Addendum No. 3

Project: Eagle Place Apartments
Subject: Addendum No. 3
Date: August 15, 2017

Project No.: 1707.01

Finish Legend

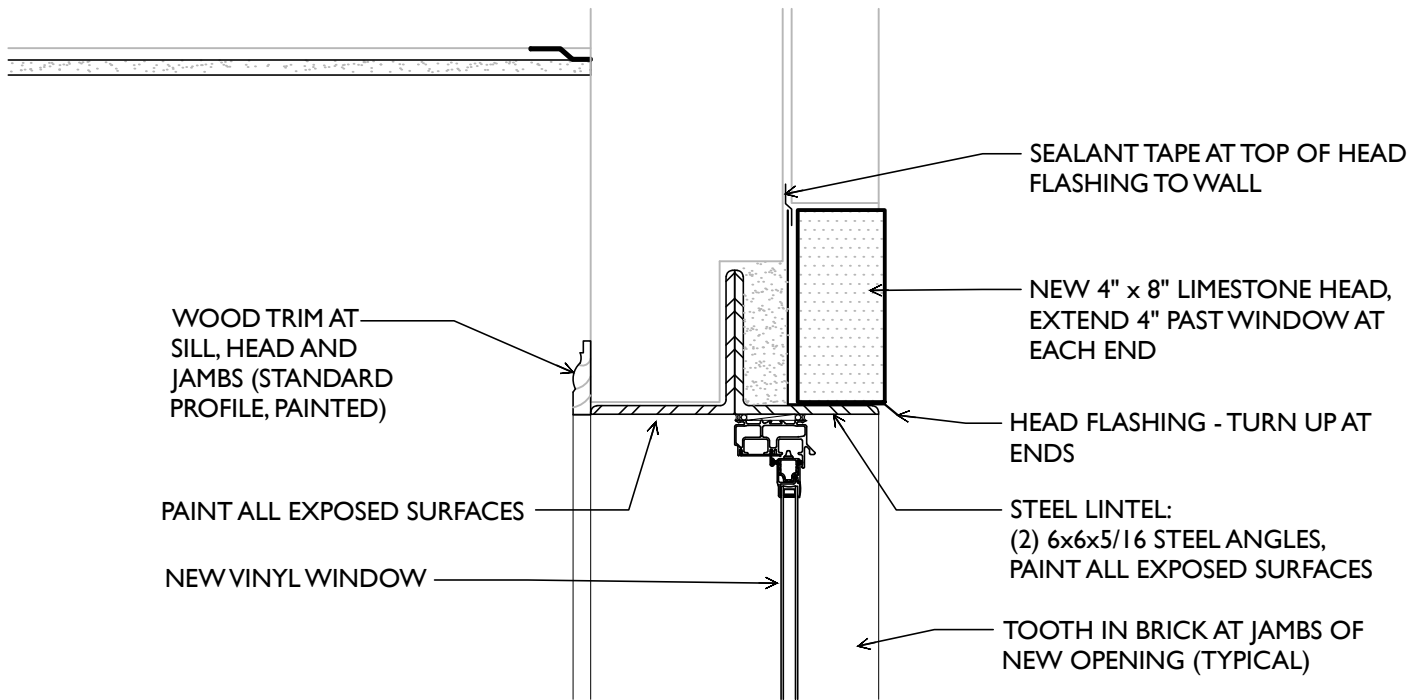
2. Drawings I-101 and I-102 additional clarification: The floor finish legend is revised per below. The hatch pattern on the left side of the legend does not read well on the color PDF drawing. It applies to the kitchen, bathroom, utility room and laundry closet in each of the 20 apartments, and to the first floor Exercise Room; Storage Room between the Exercise and Community Room; Common Toilet Room; Common area Utility Room adjacent to the Leasing office; and the Kitchennette area at the Community Room. The base bid is for terrazzo flooring to remain, and any saw-cuts for plumbing lines to be patched to match existing terrazzo. The alternate bid is to use sheet vinyl flooring at the areas indicated by the light color hatch pattern, and enumerated above. In the alternate bid, any saw-cuts for plumbing lines that occur in the sheet vinyl floor areas would be patched with concrete flush with the terrazzo.

1 Typical Window Head at New Opening in Existing Masonry Wall

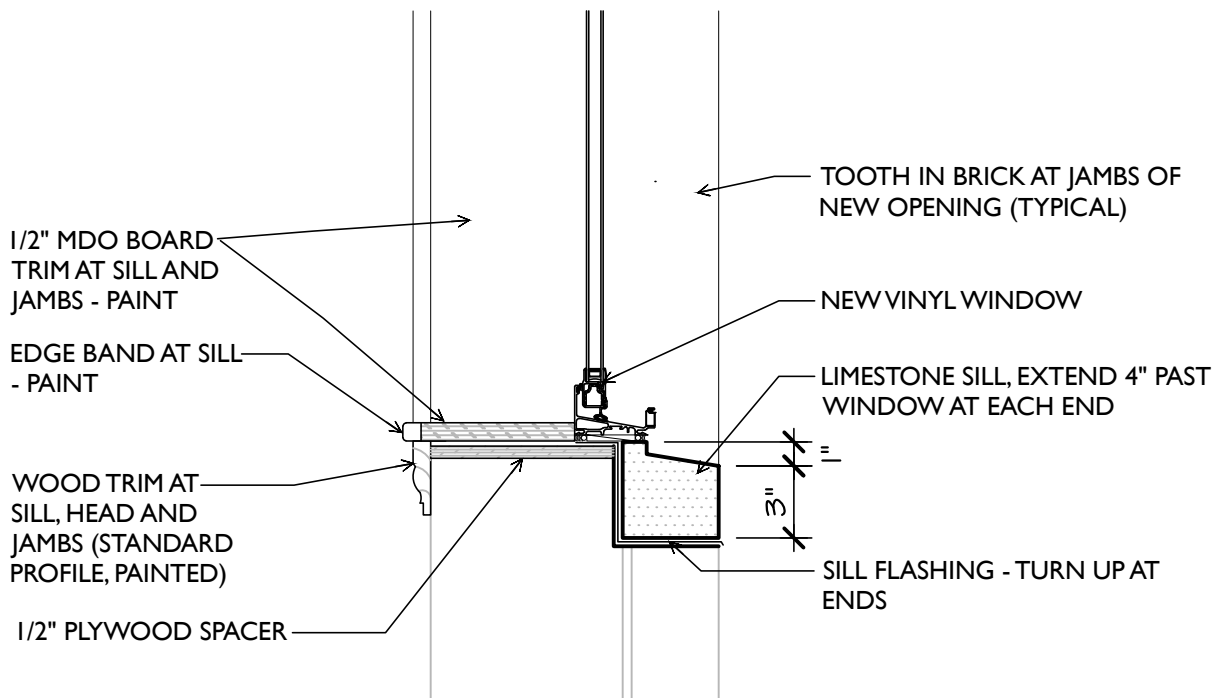
6. Drawing A803: Delete this drawing in its entirety. See attached drawings AD3-1 and AD3-2 for applicable window details at new openings in existing masonry walls, and new openings in existing metal panel walls.
